UNITED STATES PATENT AND TRADEMARK OFFICE

Office Action Summary	Application No. 10/576,580	Applicant(s) EOM ET AL.	
	Examiner AZIM RAHIM	Art Unit 3744

DETAILED ACTION***Drawings***

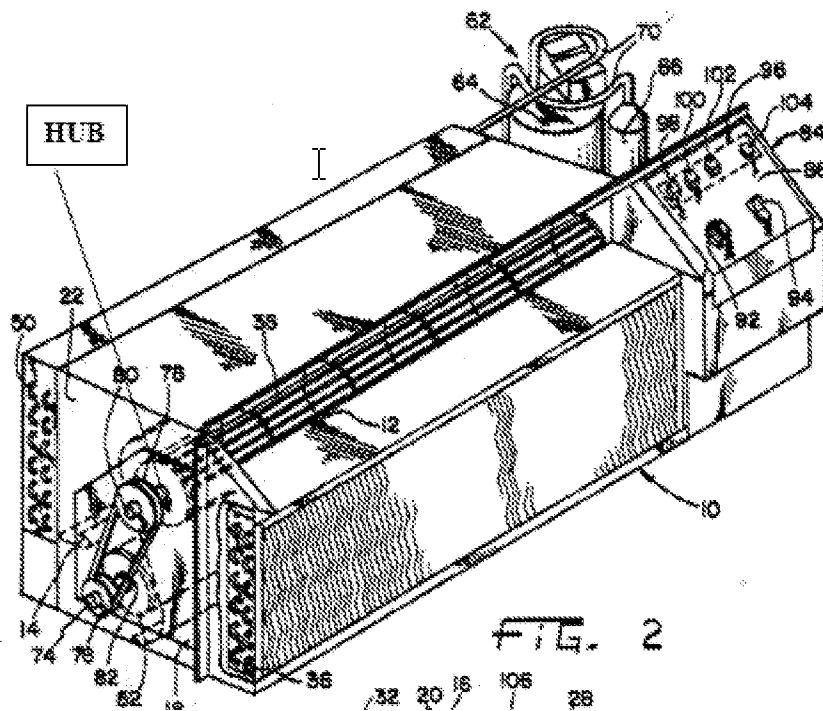
Regarding claims 6 and 20, Wollaber teaches that the indoor and outdoor cross flow fans comprise: a hub (annotated below) arranged extending in a longitudinal direction of the at least one indoor heat exchanger (illustrated below) and connected to a driving motor (72); and a plurality of blades (annotated below) provided on an outer circumferential surface of the hub

with a certain interval therebetween (illustrated below) and arranged extending in the longitudinal direction of the at least one indoor heat exchanger (illustrated below).

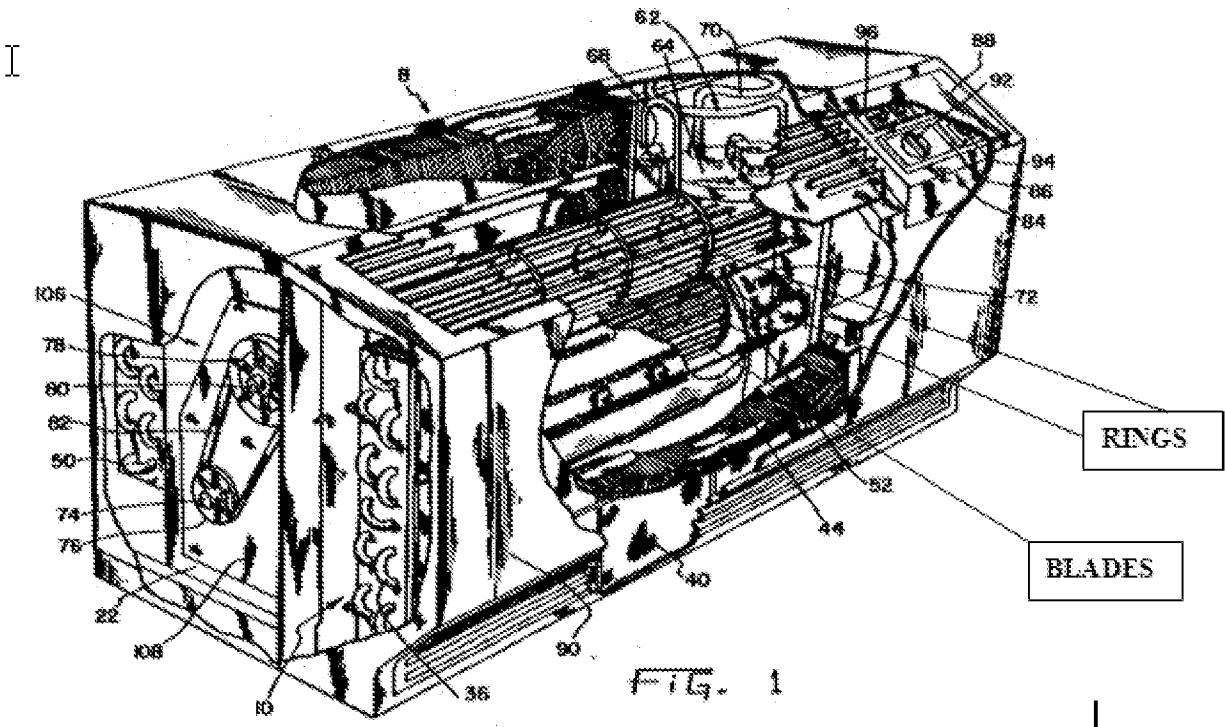
Regarding claim 14, Wollaber teaches that the plurality of blades of the outdoor cross flow fan contacts with condensed water stored in a lower portion of the case positioned on the outdoor side, thereby spraying the condensed water when the outdoor cross flow fan is rotated (as illustrated in figure 3, if condensation from condenser 50 overflows stabilizer 14 while fan 52 is sucking air through the condenser, water would contact fan 52).
